National Dam Inspection Program. Lake
Rene Dam (Lake Rene) (NDI PA-426, DER
17-102), Ohio River Basin, Tributary of
Narrows Creek, Clearfield County,
Pennsylvania. Phase I Inspection Report.

PHASE I REPORT
NATIONAL DAM INSPECTION PROGRAM

NAME OF DAM: Lake Rene Dam
STATE LOCATED: Pennsylvania
COUNTY LOCATED: Clearfield County
STREAM: Narrows Creek, a tributary of Sandy Lick Creek
DATE OF INSPECTION: April 2, 1979 and May 4, 1979

PLATE 3

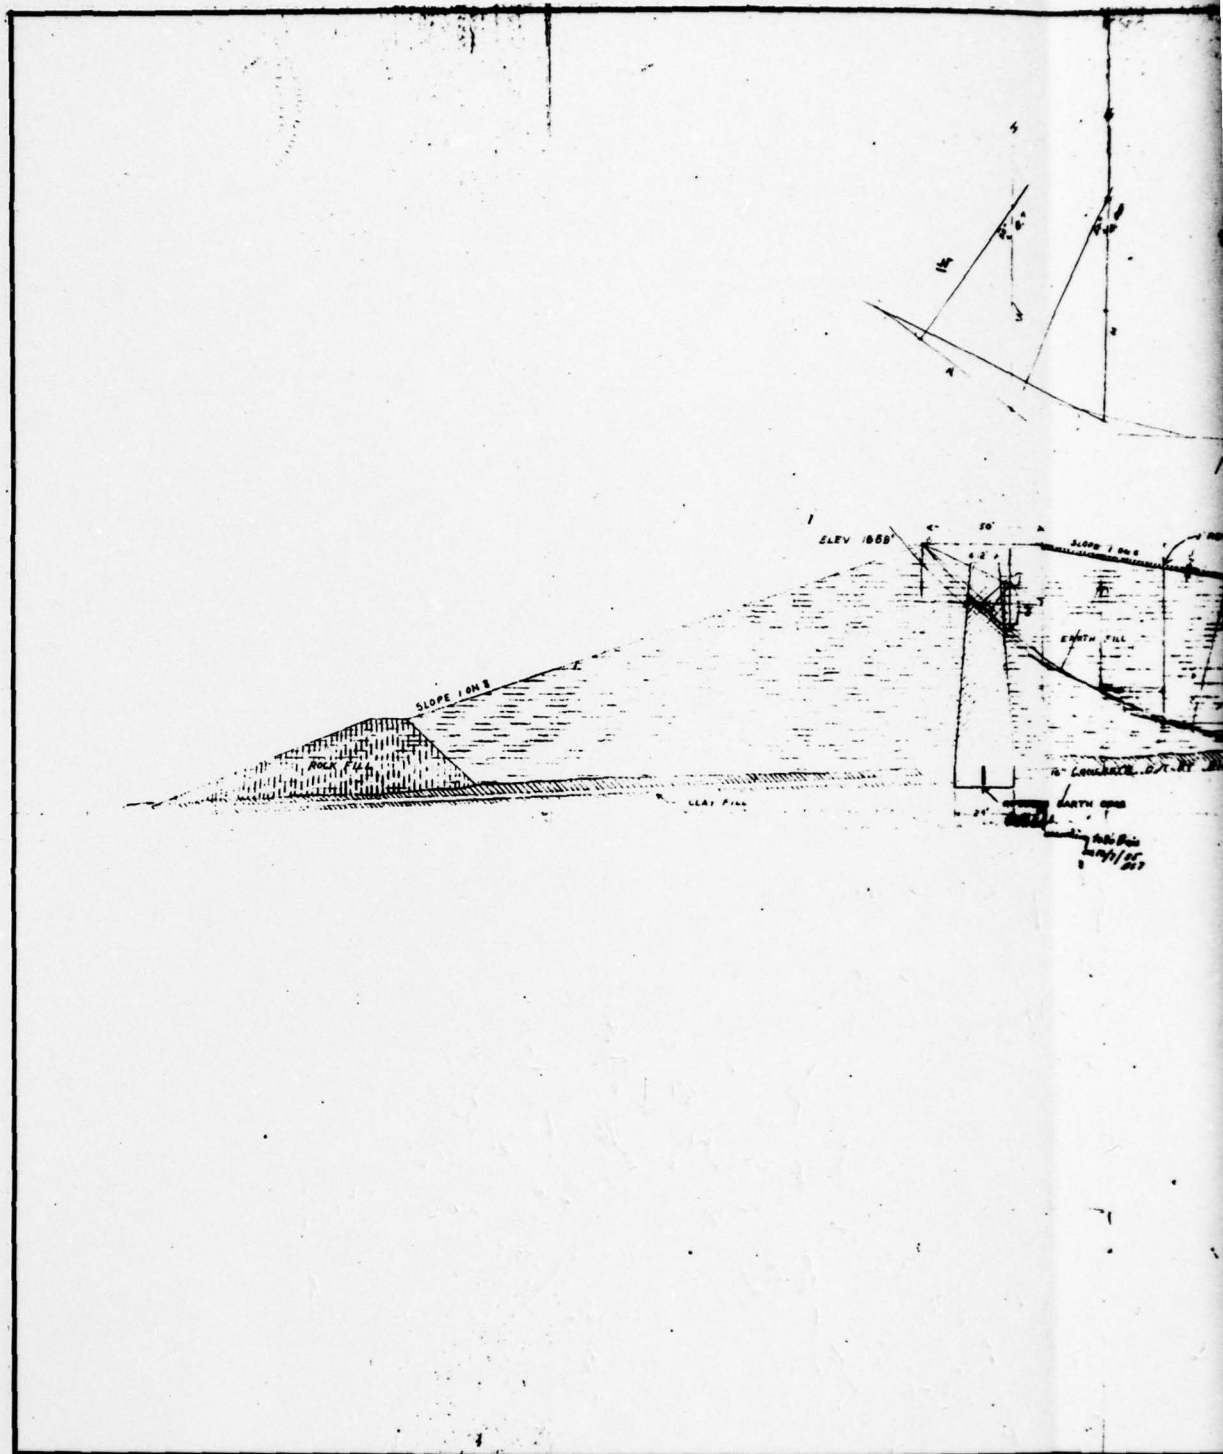
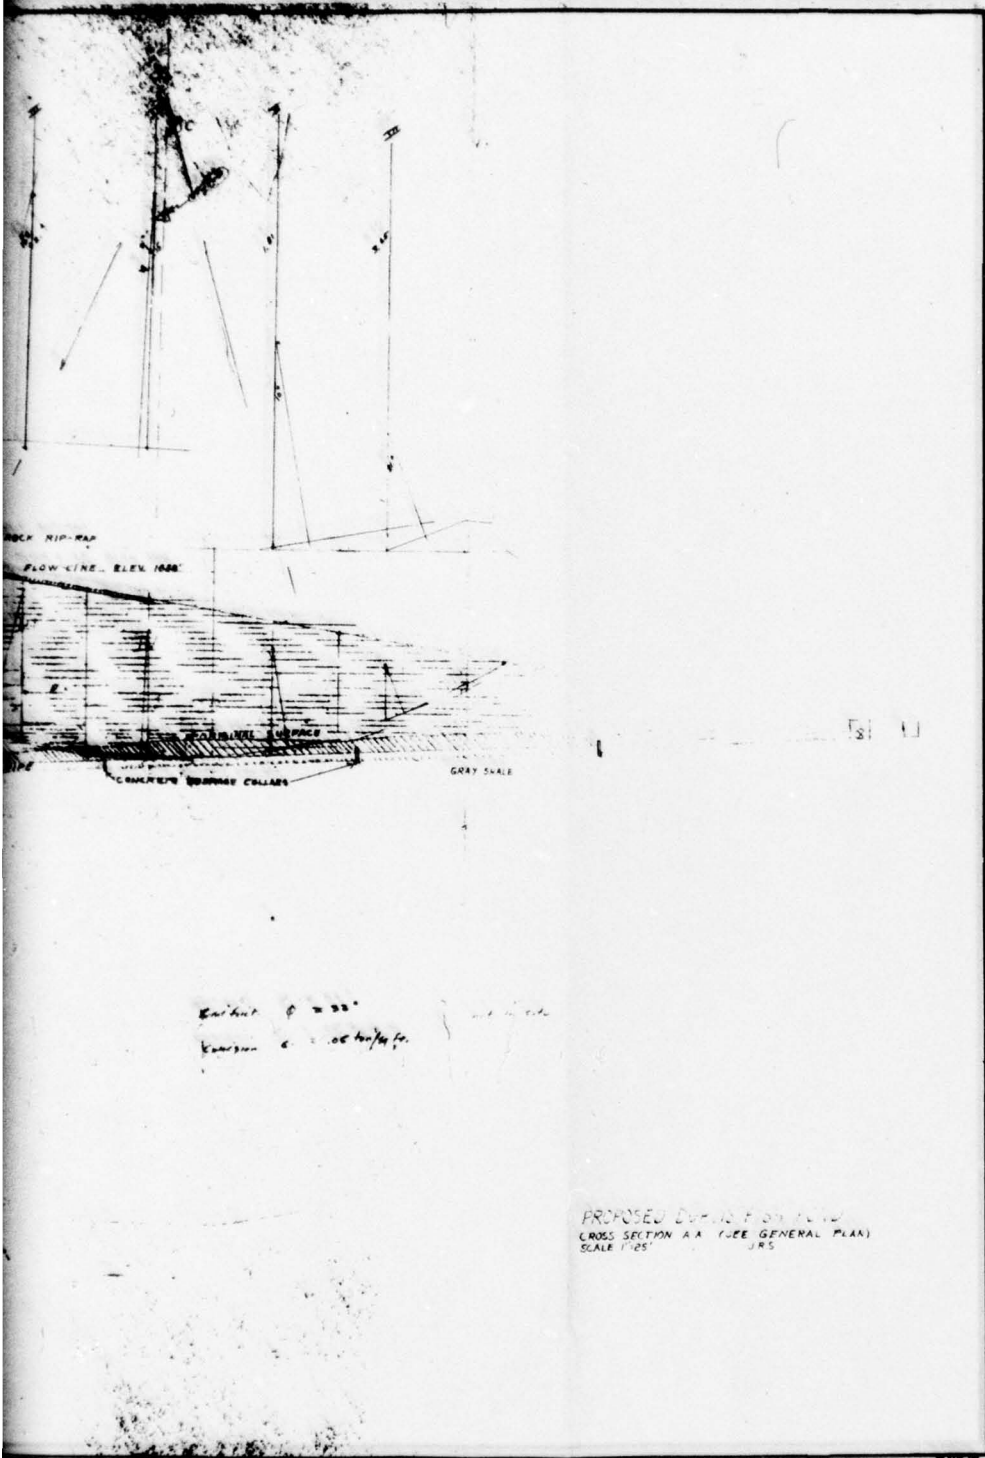
(1) Embankment. As shown in a design sketch (Plate 2), the dam is a zoned embankment (Plate 3) consisting of a central impervious core with shale sections downstream and upstream and a rock-fill section at the toe of the downstream slope. The impervious core section is shown to be 24 feet wide at the base of the dam and 12 feet wide at about Elevation 1660. The same drawing shows the downstream face of the dam to have a 3H to 1V slope, while the upstream face was shown to have a slope 6H to 1V. However, field observations suggest that the dam was not constructed according to this design sketch. The downstream face of the dam was found to be much steeper than 3H to 1V. No evidence of a rock fill at the downstream toe of the dam was found. As it exists, the downstream face of the dam is 1.3H to 1V from crest elevation to a point approximately 15 feet below the crest, 2H to 1V for another 15 feet and 3H to 1V for the rest of the downstream slope. The portion of the upstream slope above normal pool elevation was found to have a slope of 2.5H to 1V.

(2) Embankment. Although references were found to indicate very limited subsurface investigation, laboratory soil testing and analyses were performed. Data appear to be in preliminary form and were not incorporated in a comprehensive design. No references were found to indicate the type of material used for the embankment construction or the manner in which the embankment was constructed. A construction drawing shows an impervious core section for the embankment. However, no formal documents were found as to whether this impervious core was actually constructed. As shown in a construction drawing, the design lacks foundation cutoff and internal drainage of the embankment.

Photograph No. 3

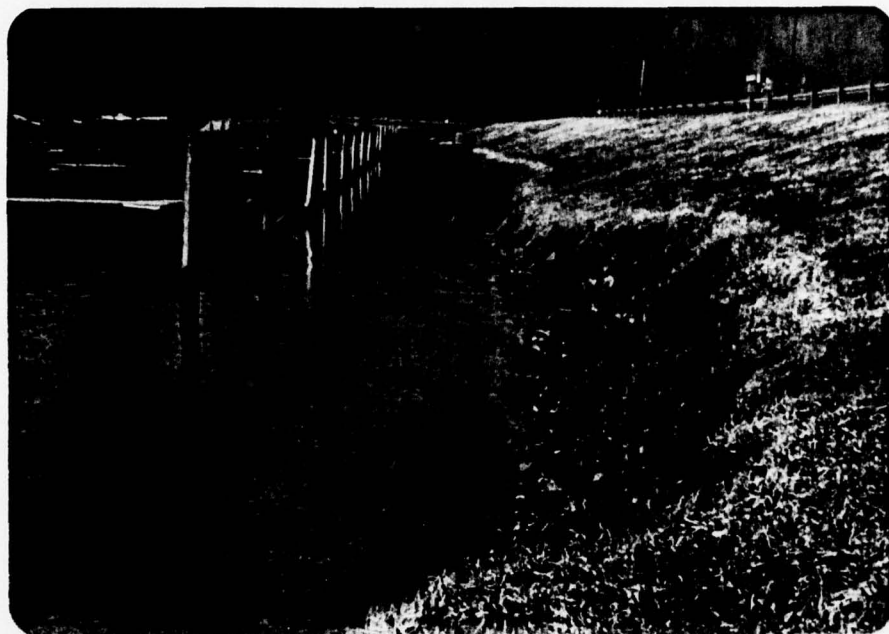
Upstream slope shoreline erosion.

2. The upstream face of the dam should be provided with adequate erosion protection to avoid further shoreline erosion.
3. Around-the-clock surveillance should be provided during unusually heavy runoff and a formal warning system developed to alert the downstream residents in the event of emergencies.
4. The dam and appurtenant structures should be inspected regularly and necessary maintenance performed.
